Twin Moon Roof

Back Door Outside Handle

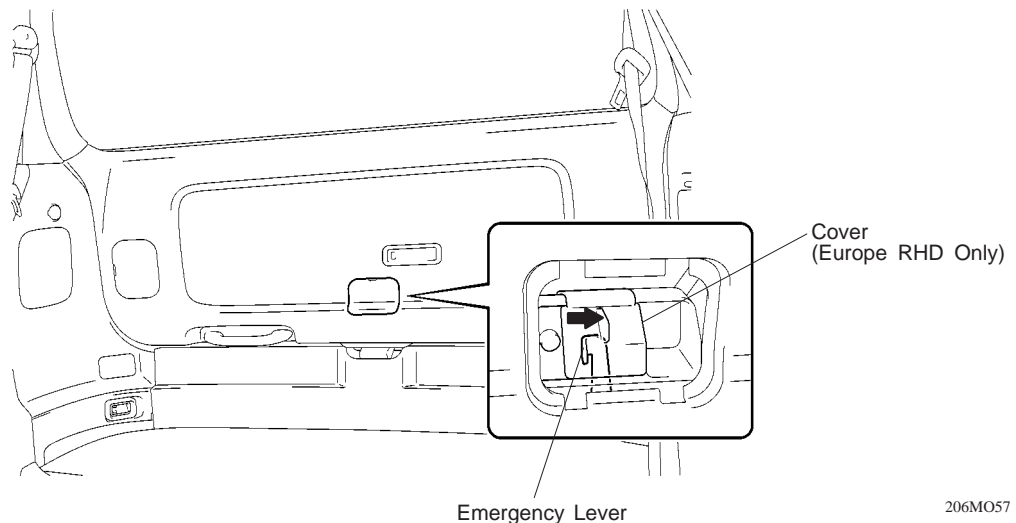
- A new system has been adopted, in which a switch within the back door outside handle functions to unlock the back door electrically. The back door key cylinder has been discontinued.
- After the side door is unlocked with the transmitter, door lock control switch, or door key cylinder*, if the back door outside handle switch is operated, the linkage of the back door lock striker and the back door lock is released, and the back door will open. (*: Except Europe RHD models)

- If the battery is overdischarged or any electrical trouble arises and the back door outside handle switch will not unlock the door, the emergency lever inside the cabin will unlock the door.
